Access Compliance Report Public Rights-of-Way (Curb Ramps)

Main Street: N_SHERI_ST Cross Street: BIXBY_AVE Location: NE

ADA ID: RPAT210924124027 Ramp Type: Type 7 - Directional 2 Initial Pass/Fail: Fail Overall Compliance: No Severity Score: 30

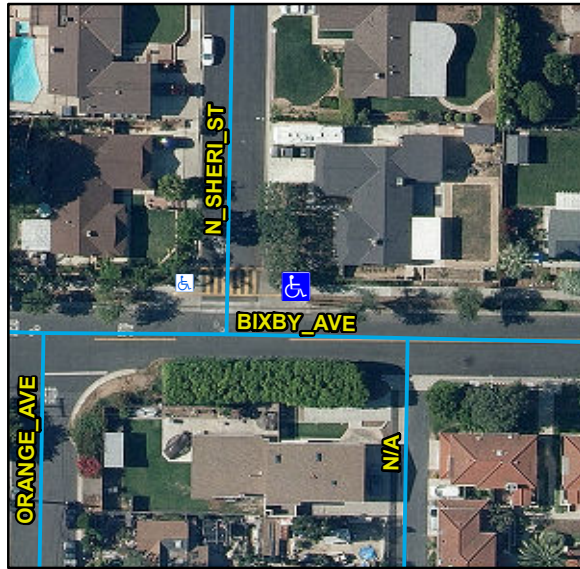
R204.3, R304.2.2, R304.5.3, STD 1115

Remove & Replace Entire Ramp. Restripe Crosswalk.
